RE: Appeal of Building Permit; 20 Central Street, LLC

ROCKPORT HARBOR HOTEL

20 Central Street, Rockport, ME 04856

EXHIBIT B

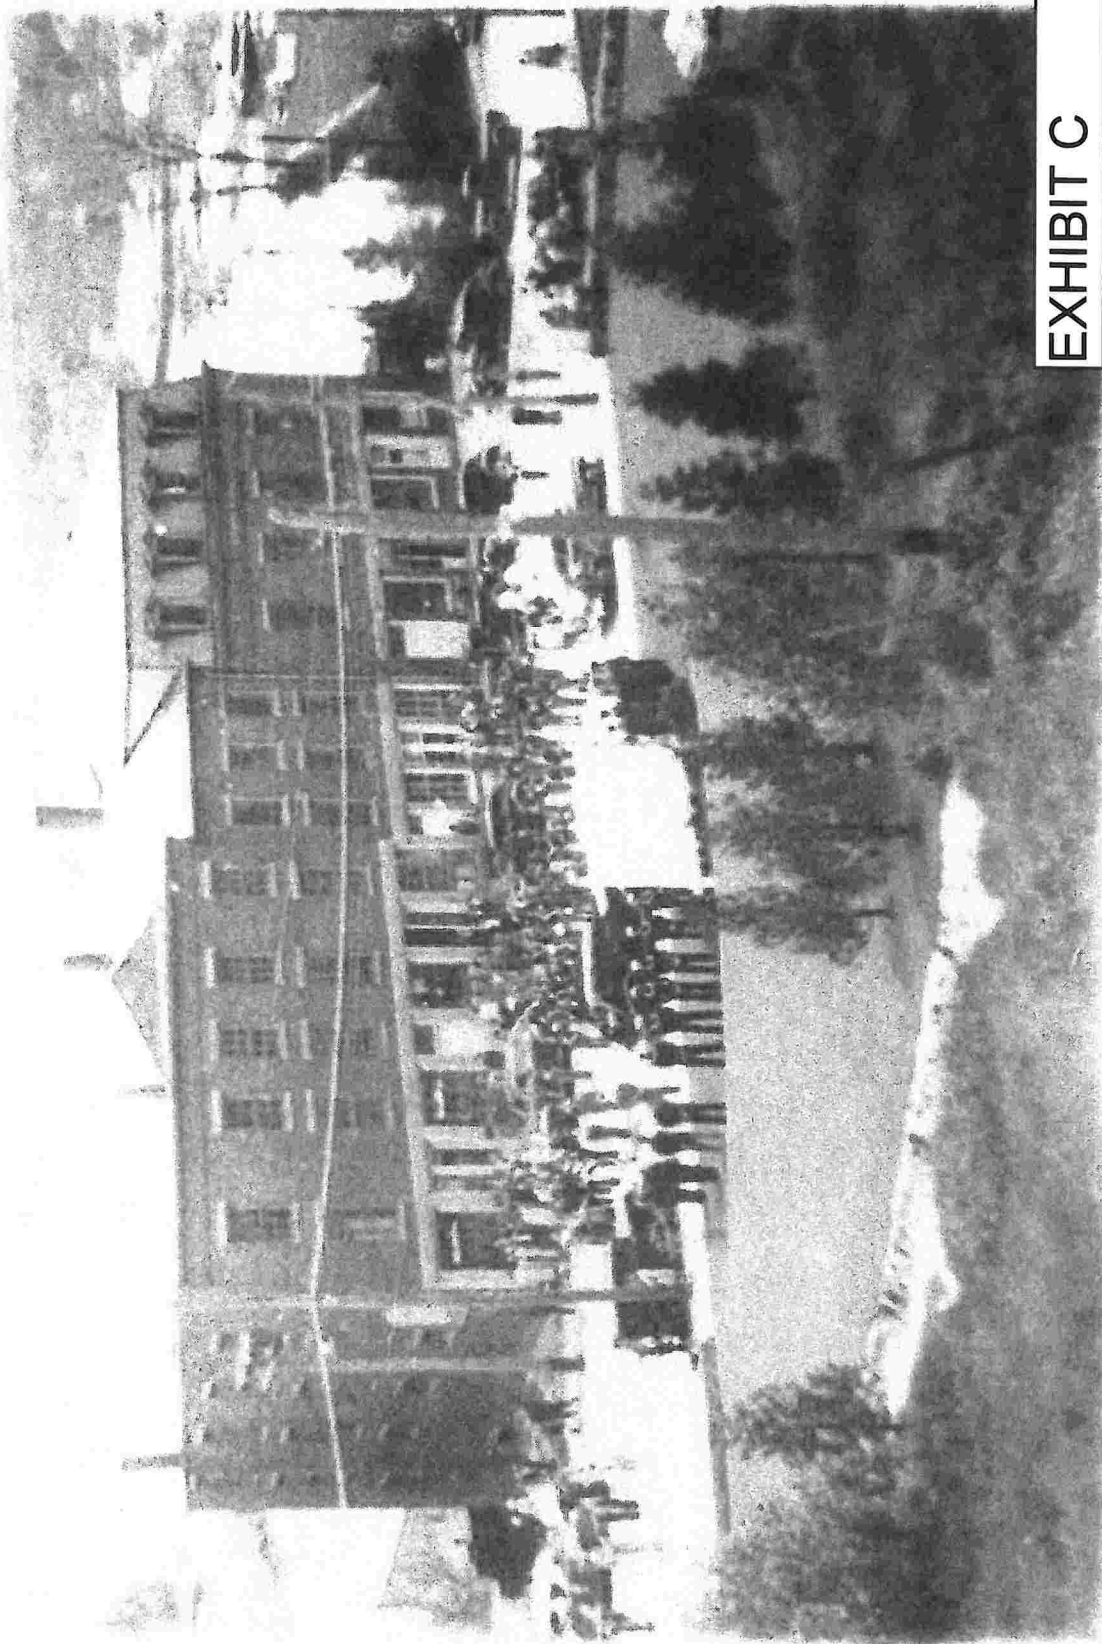
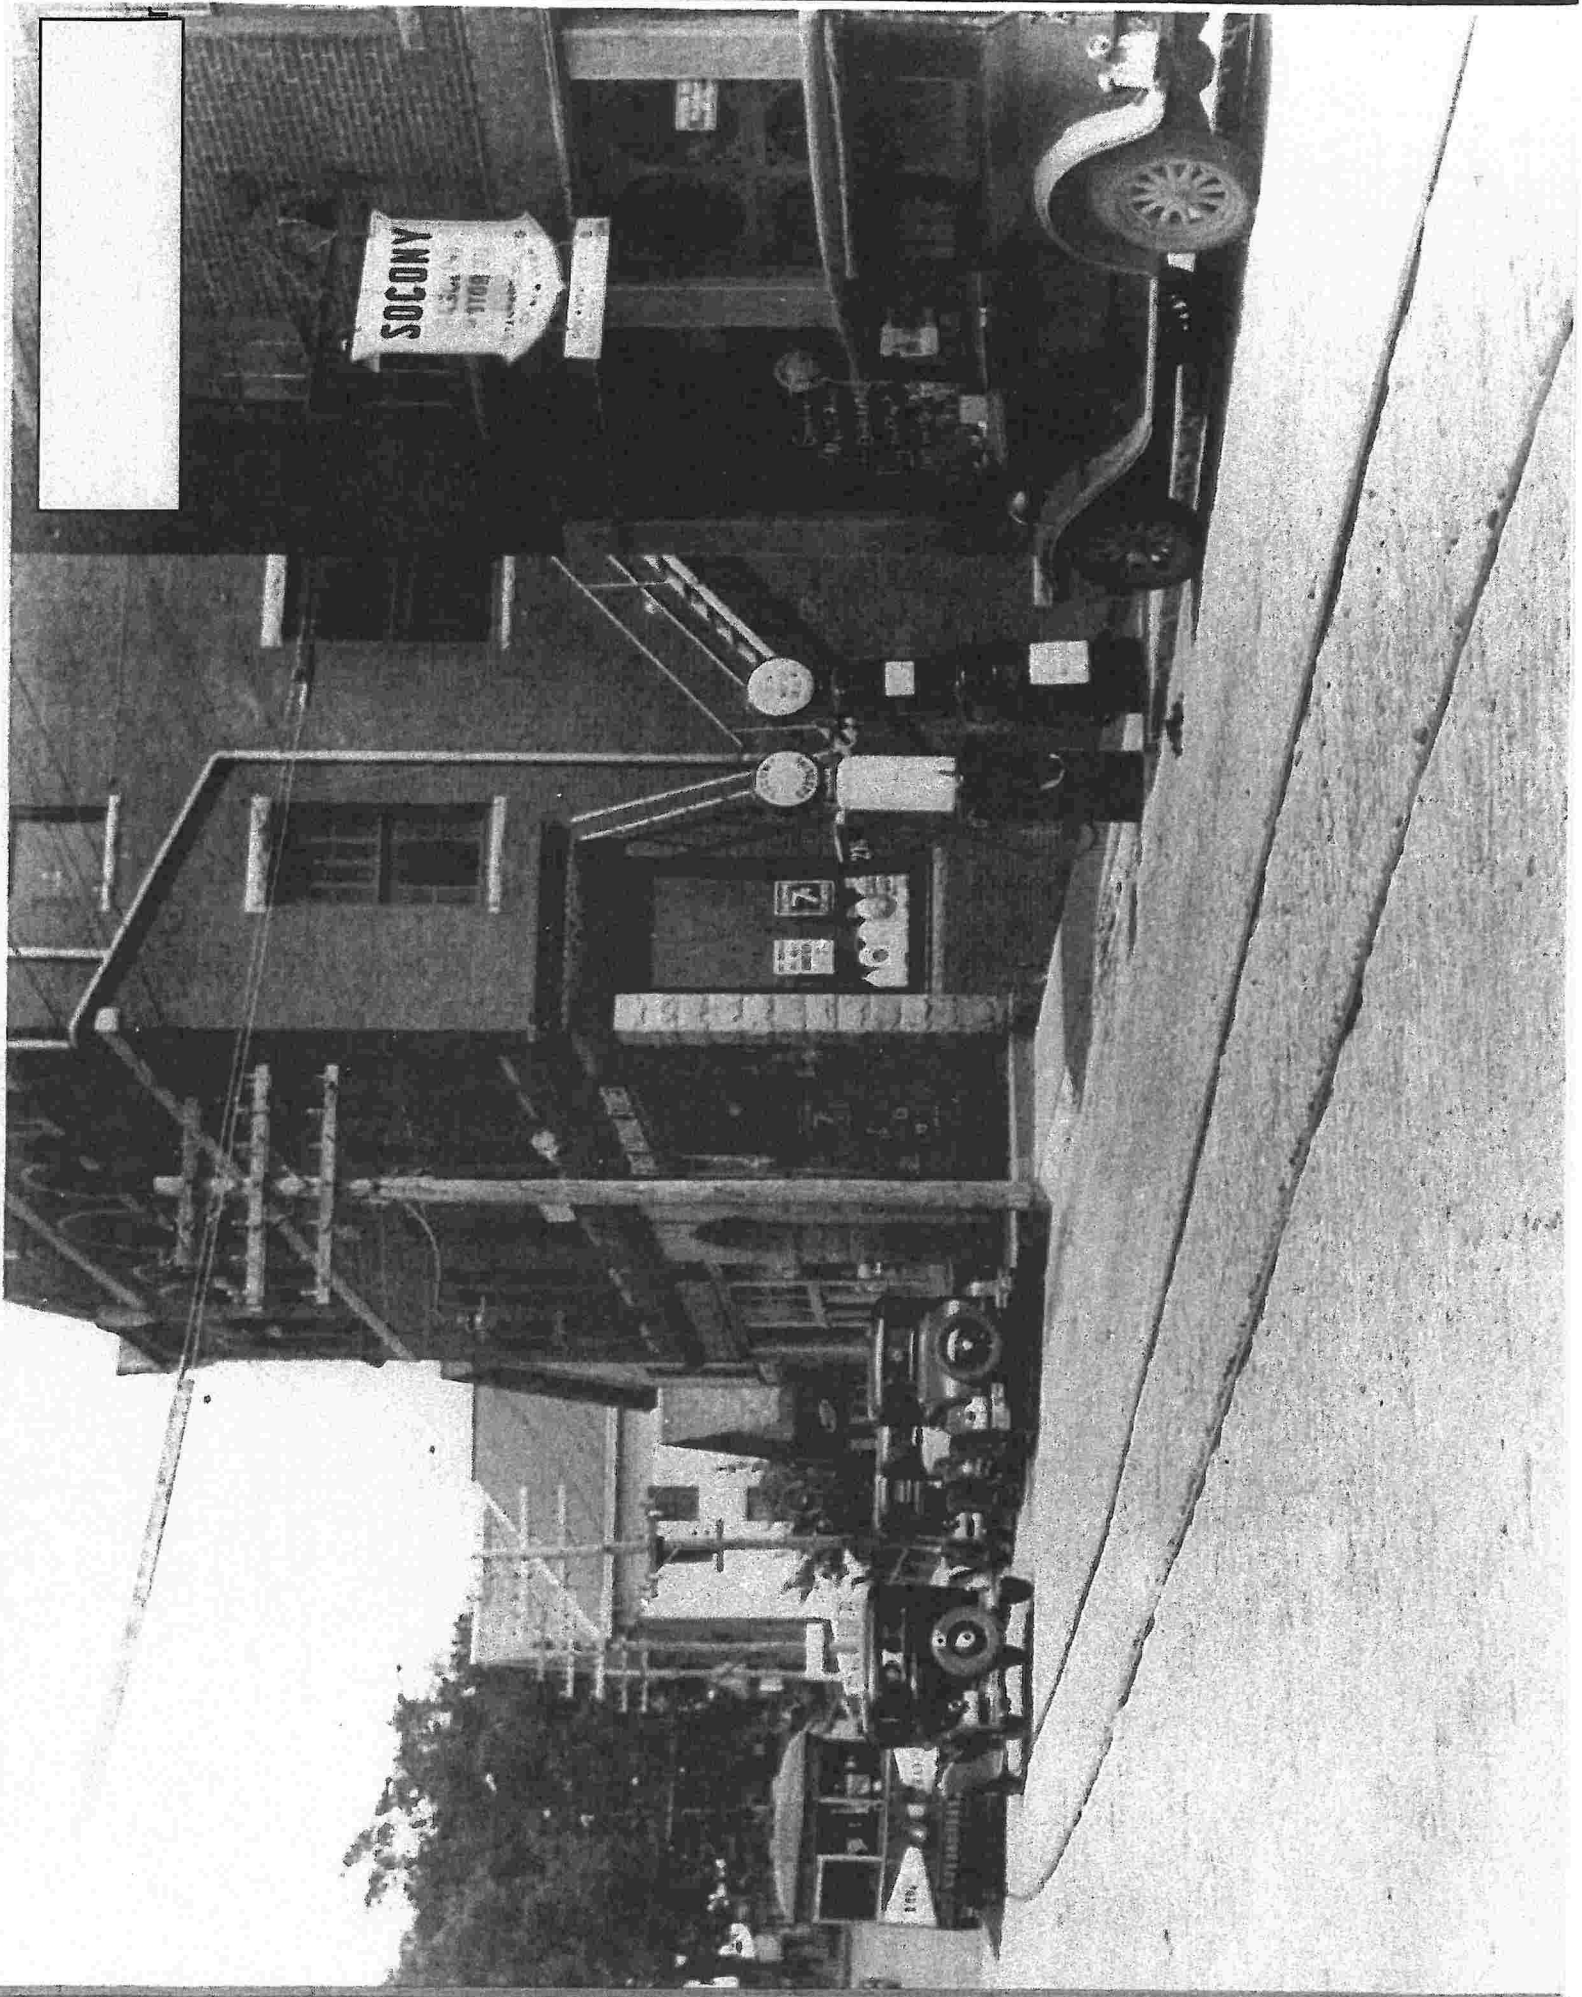
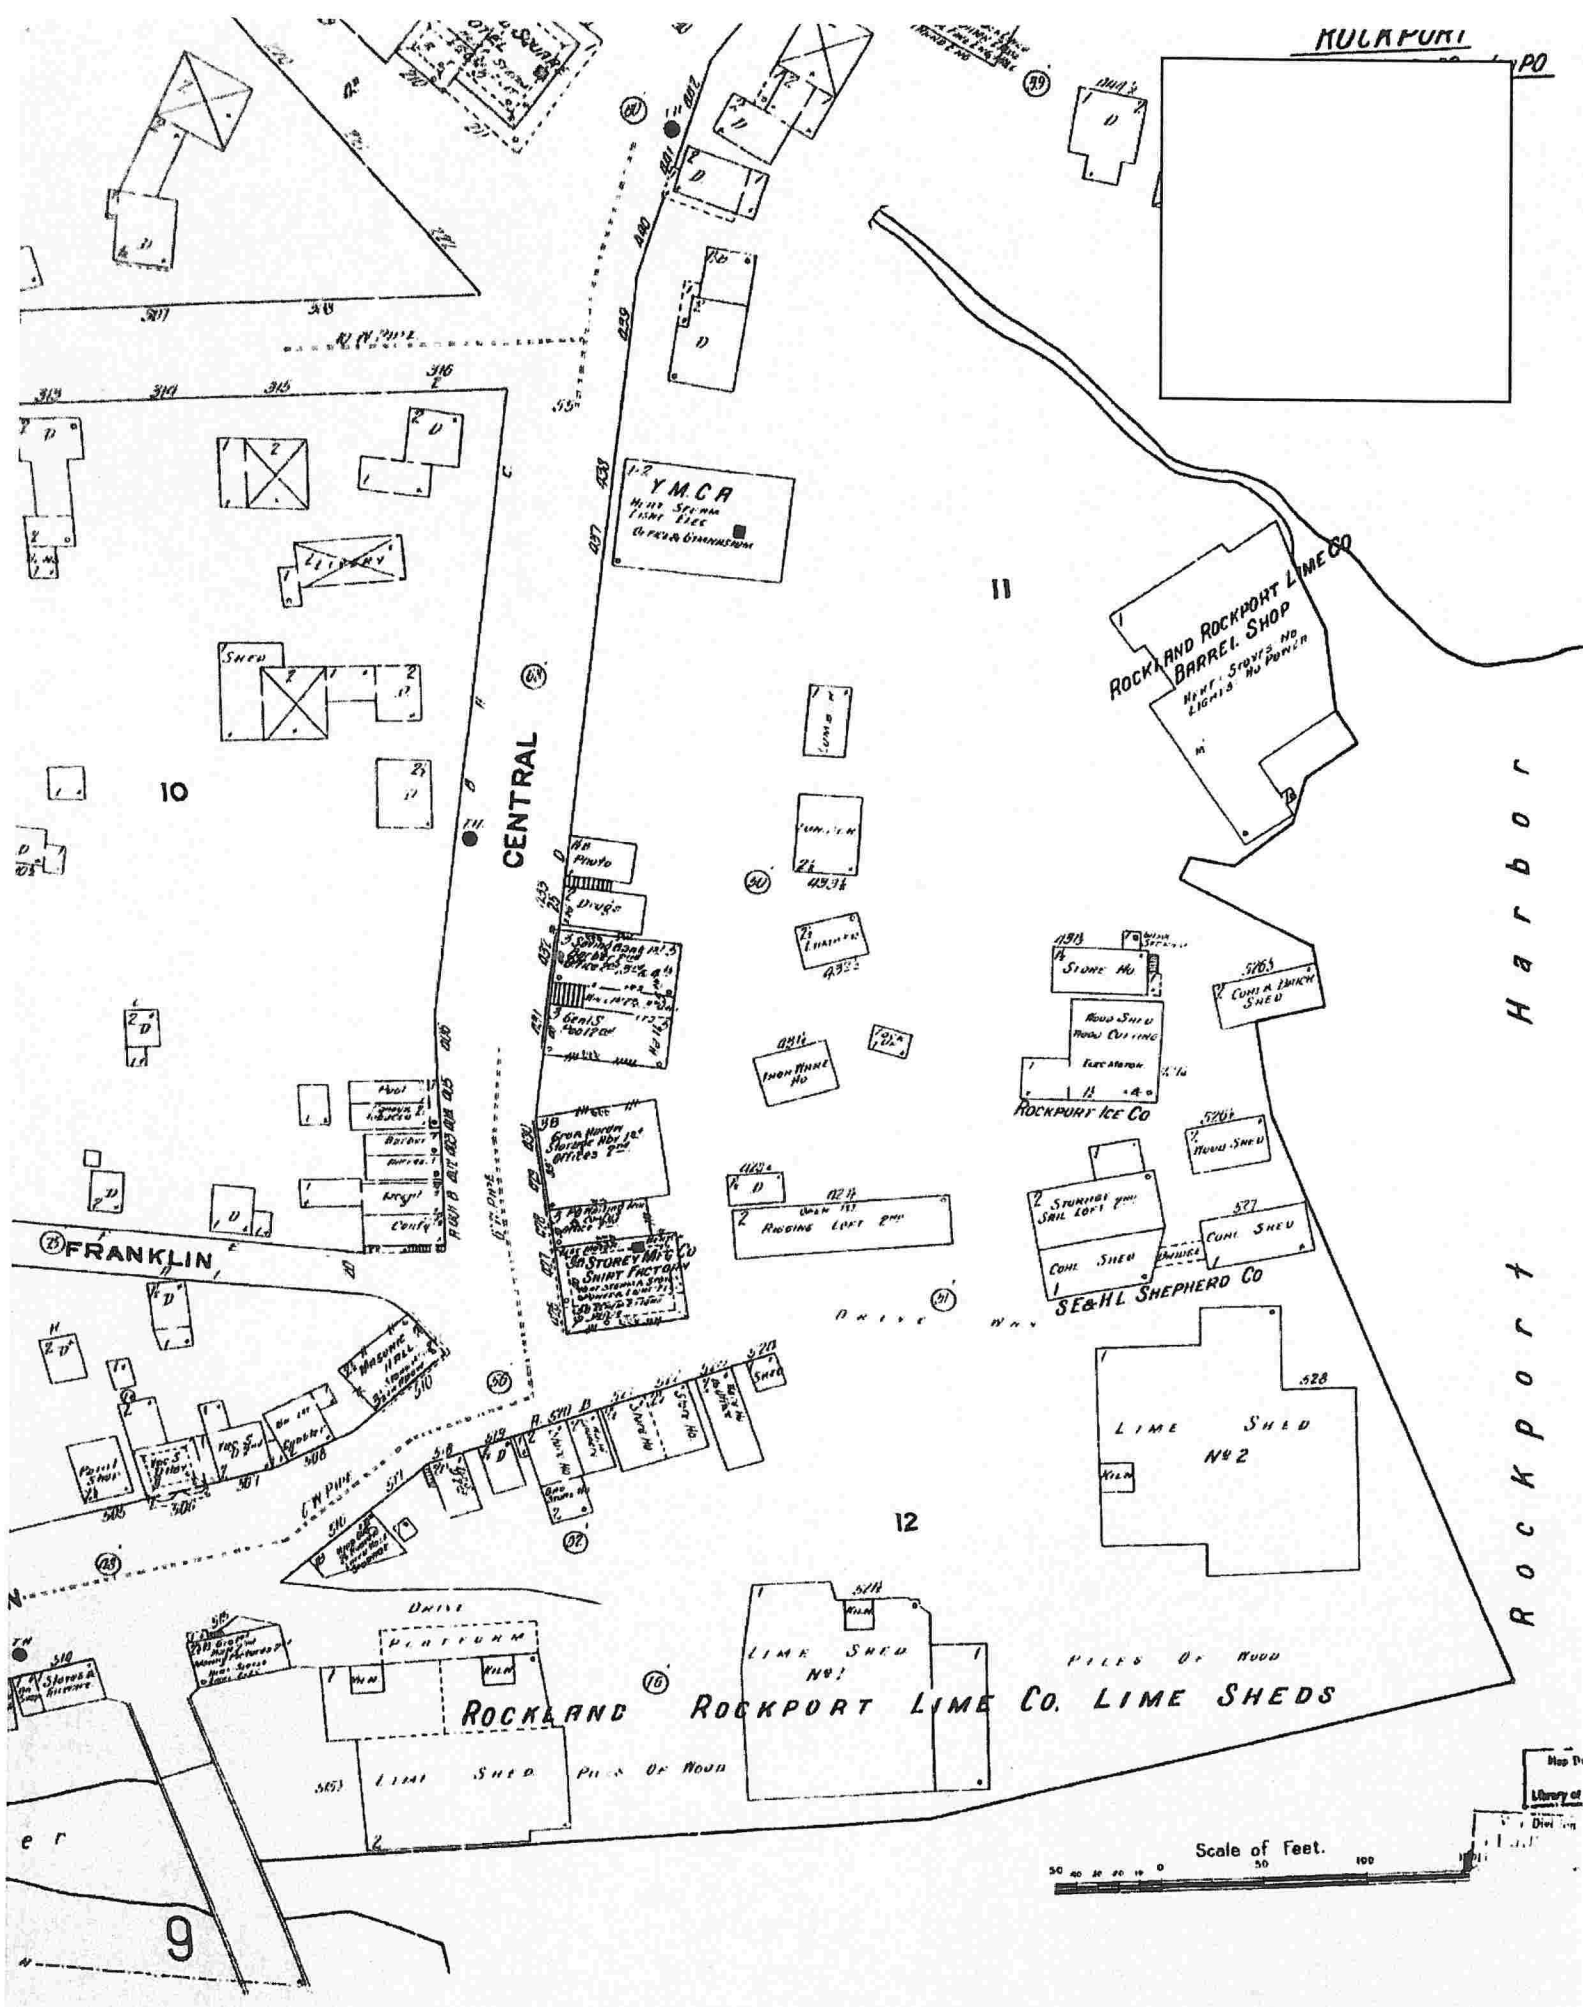
1. The hotel is not “located and configured in a visually harmonious manner with the terrain and vegetation of the parcel and surrounding parcels.” “The architectural design of [the structure] and [its] materials and colors” is not “visually harmonious with the overall appearance of neighboring structures.” The hotel is being located on a block of structures that are all very similar in era and design, but as designed it contains many architectural elements which are not harmonious with those other structures. This is especially problematic given Rockport Village’s designation as a historic place deserving of extra protections. For reference, see exterior building plans attached as Exhibit B.

- a. The balconies on the front and rear are incongruous with the rest of the block. There are no current protrusions on the front of the block, which overlooks private residences on Central, Franklin and Main Streets. The back of the block currently features only a few modest decks.

- c. The balconies do not fit the New England vernacular, and the sheer number of them is visually imposing.
 - d. The hotel will eliminate the current side façades of abutting structures, including their windows, defacing the iconic Shepherd Block building, a federally recognized historic building.

- e. The mass of the façade is, overall, not consistent with the mass of other buildings on the block.
 - f. The building is set back from the sidewalk, unlike the other buildings on the block.

- g. The proposed design features mulled (double) windows, unlike the other buildings on the block.
 - h. The proposed design lacks the ornate, corbelled brick cornice of the other brick buildings on the block.

- i. The façade of the building (both front and rear) has far more glass than on the other buildings on the block. The rear of the building overwhelms the more sedate, historic rear façades of the neighboring buildings and is visually imposing when viewed from the harbor.

- j. The size and proportion of the windows in the design are smaller than and not in keeping with the surrounding structures.

- k. The stories of the hotel facing Central Street are disproportionate to the other buildings on the block.
 - l. The first floor of the hotel is several steps up from the street, which differs from surrounding buildings, all of which have their first story at or within one step of the sidewalk.

- b. The elevations have been changed to show numerous “decorative columns” on the Central Street façade. These are both more numerous and of a substantially different design and character than shown on the elevations presented to the Planning Board. Remembering that this is a historic district, these changes are material to the issue of whether the design is in keeping with the architectural character of the block. Such columns are not found anywhere on Central Street.
- c. The building plans show numerous other differences from the elevations presented to the Planning Board:

- i. The elevations submitted to the Planning Board showed the front entry with two offset stairs and two doors; the building plans show one stairway and one door.

- ii. The arches to the sides of the main entry are substantially different and more ornate than shown to the Planning Board.
- iii. There is an additional doorway shown on the front of the building, and railing is not as originally depicted.

- iv. The four central room balconies went from full-width to door-width.
- v. The room windows were shown as four-over-one; the building plans show one-over-one.

- vi. The building plans show the room windows located lower on the wall than in the elevations.
- vii. The elevations presented to the Planning Board showed the dormers as extending past the doorframes. The building plans show them as being door-width.

- viii. The original elevations showed a curve in the sides of the mansard roof, with a bracket underneath (more like Union Hall). The building plans show a straight roofline and no bracket on both the front and rear facades.

- i. The elevations submitted to the PB showed arches over the porches on the lobby level; these are now gone.
- ii. The elevations to the PB showed consistent arch design between the lobby and top floors; they are now inconsistent.
- iii. The elevations to the PB showed four individual doors at the lobby level; the building plans show two doors and large folding glass doors at the center.
- iv. The elevations to the PB showed overhanging arched roofs matching the archways below; the building plans show peaked roofs with no overhang.
- v. The building plans show a large continuous balcony with railing panels at the top level that are either glass or opaque. These were not shown in the elevations submitted to the Planning Board.
